NORTHEAST UTILITIES

Millstone Nuclear Power Station, Unit Nos. 1 and 2
Additional Information Regarding Appendix R
Exemption Requests

Additional Information Regarding Appendix R
Exemption Requests

SKETCH # Q1-1

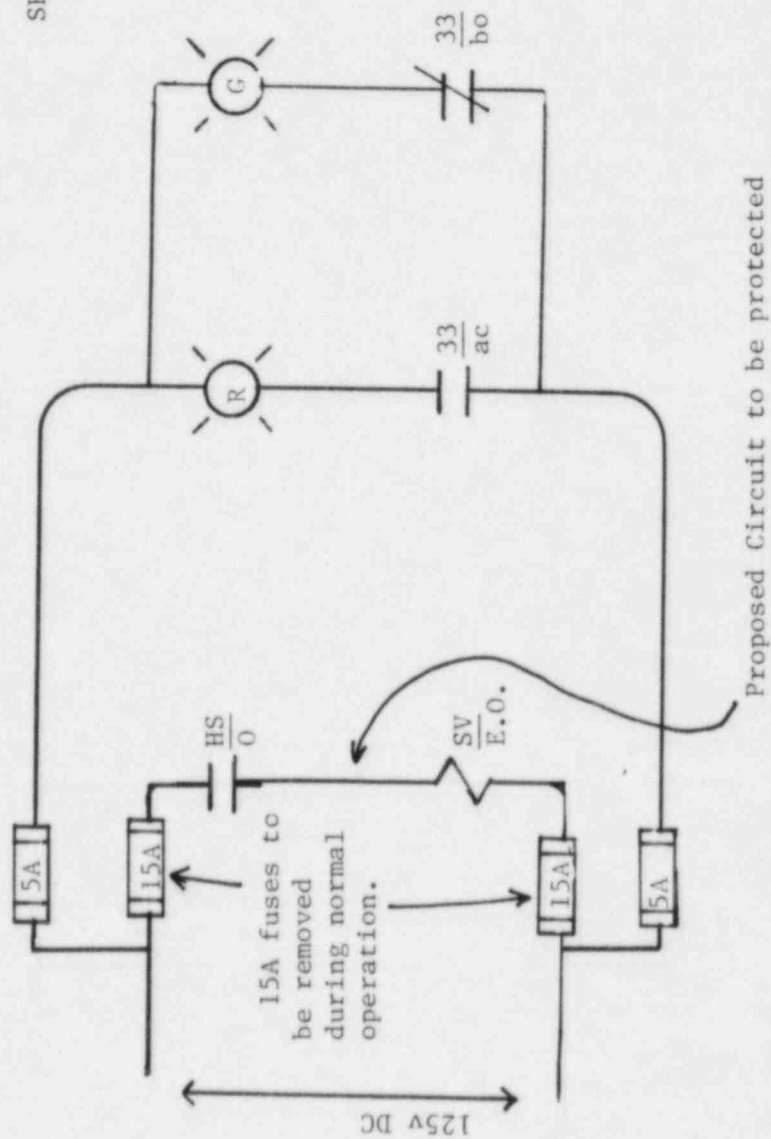
2. Reference (2) did not specify what protection will be used to eliminate the susceptibility to hot shorts for the Unit 2 pressurizer and reactor head vent control circuits during a control room fire. Please specify.

The pressurizer and head vent control circuits will be modified to protect against hot shorts from control room fires. The modification as detailed in Sketch Q1-1 shall consist of removing the fuses to the pressurizer and head vent control circuits during plant operation. The indication portion of the circuit shall be separately fused such that valve indication will not be lost when the fuses associated with the solenoid valves are removed. The second measure of protection shall be to insure the switchboard wire associated with the solenoid valves shall not be susceptible to hot shorts. This may be done by any of the following modifications:

- 1) Special fire rated wire.
- 2) Existing wire protected from hot shorts by running individual conductor in conduit.

- 3) Fire rated wrapping material.
- 4) Mineral insulated cable/wire.

SKETCH #Q2-1

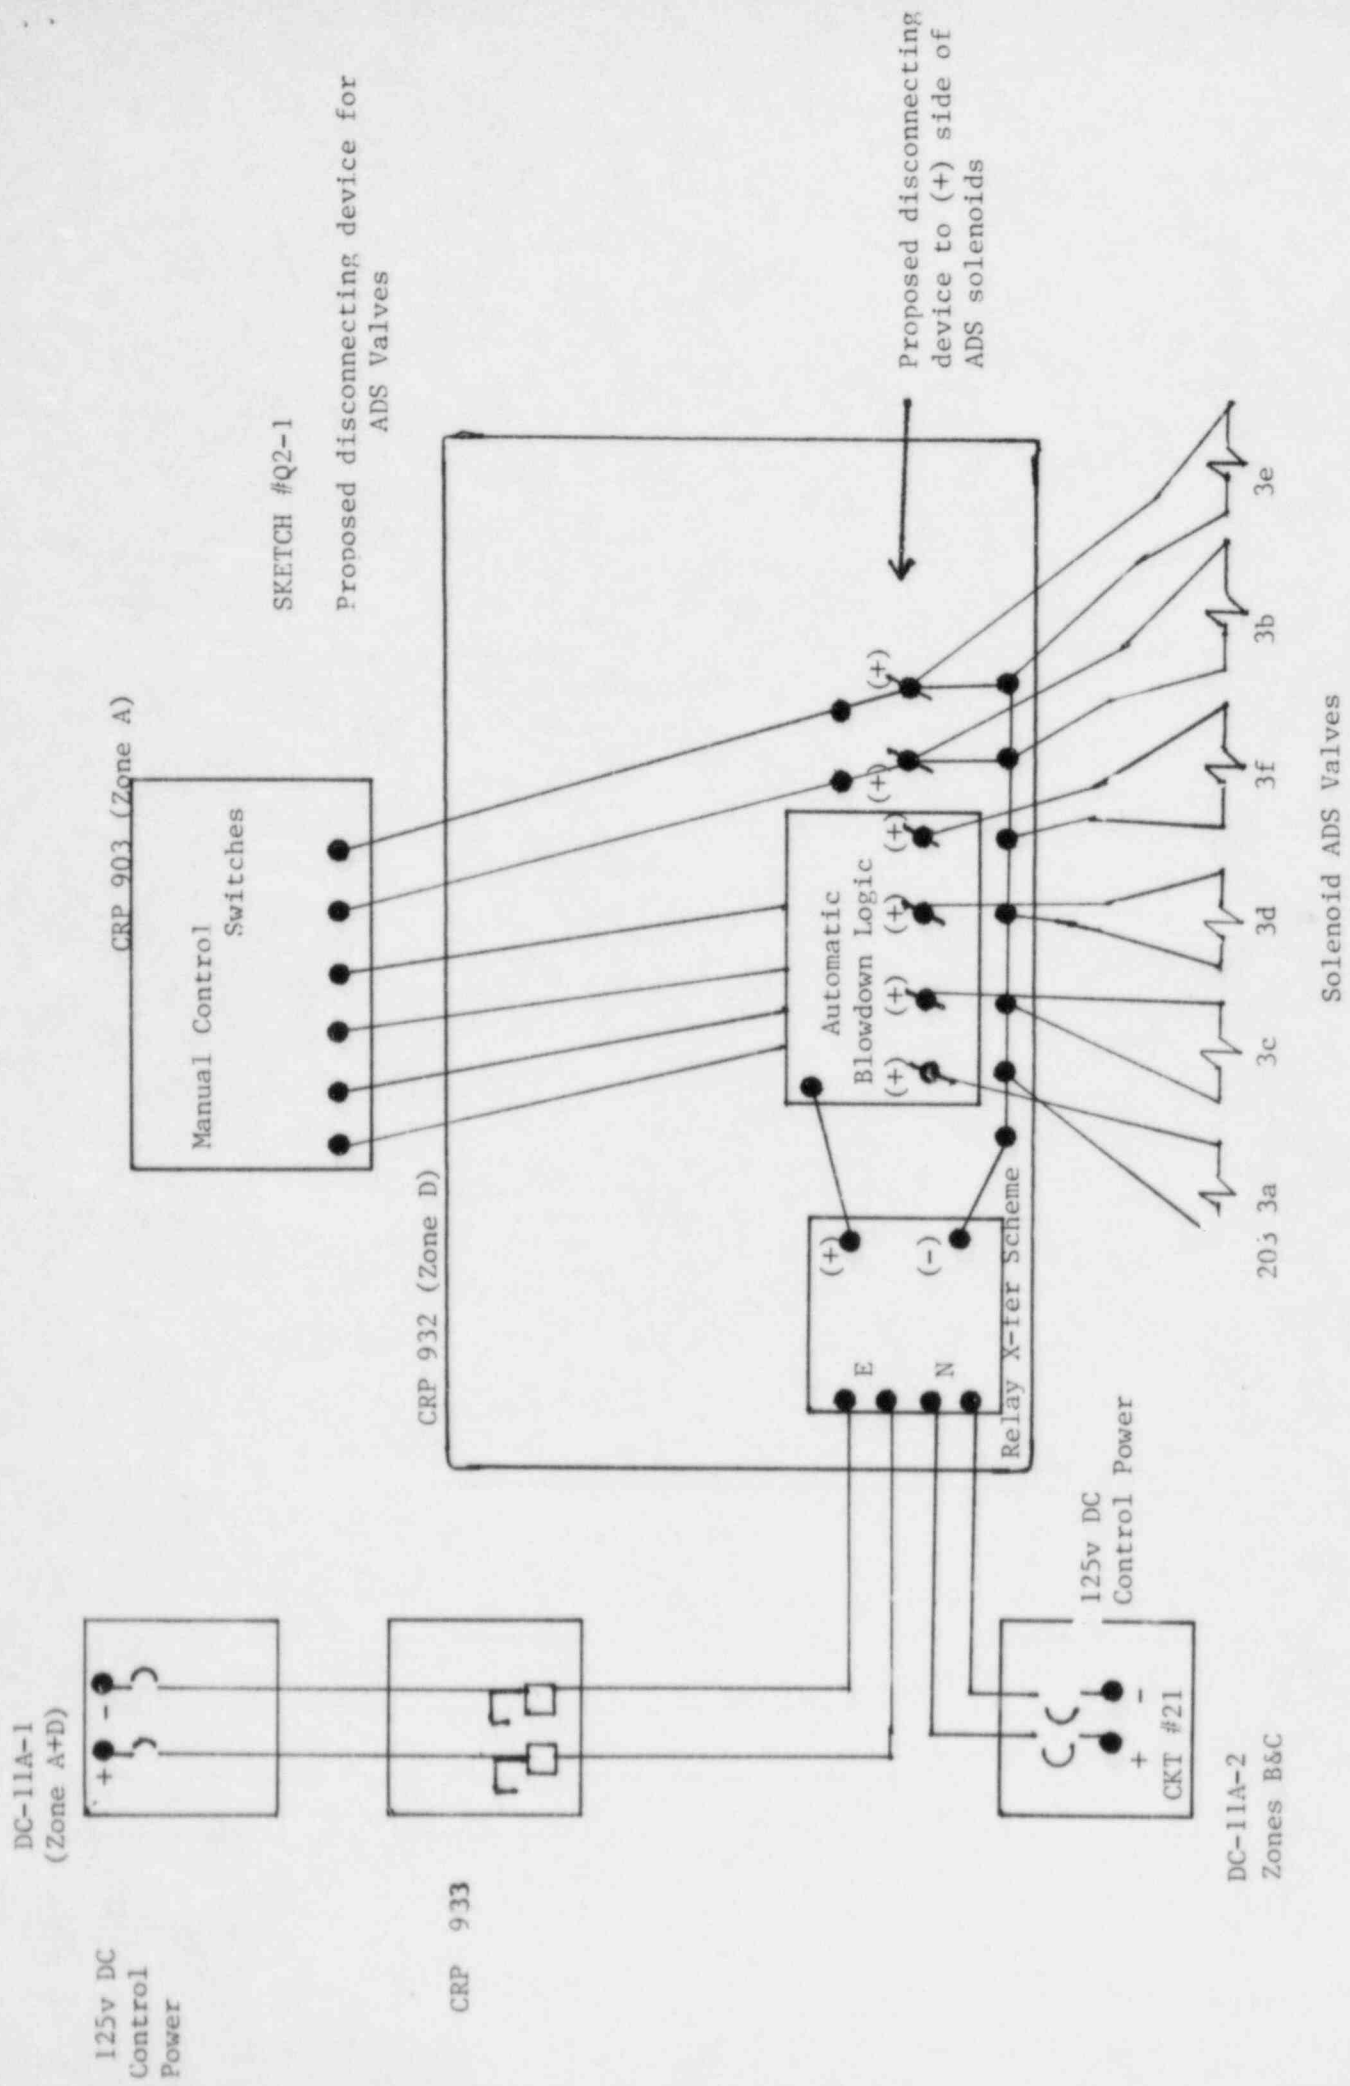
3. Reference (1) did not specify what disconnect device will be installed in the Unit 1 ADS valve control circuitry to assure the valves remain closed during a control room fire. Please specify and provide a control wire diagram.

The proposed manual disconnection device (e.g. a knife switch) depicted on Sketch Q2-1 will assure the control room operator that the ADS valves remain closed for a postulated control room fire in Zone A which disables main control board panel 903. The manual disconnect devices will be located in auxiliary control board panel 932 in Zone D. A description of operator actions required for a fire in auxiliary control board panel 932 is described in Table 1 of Reference (1).
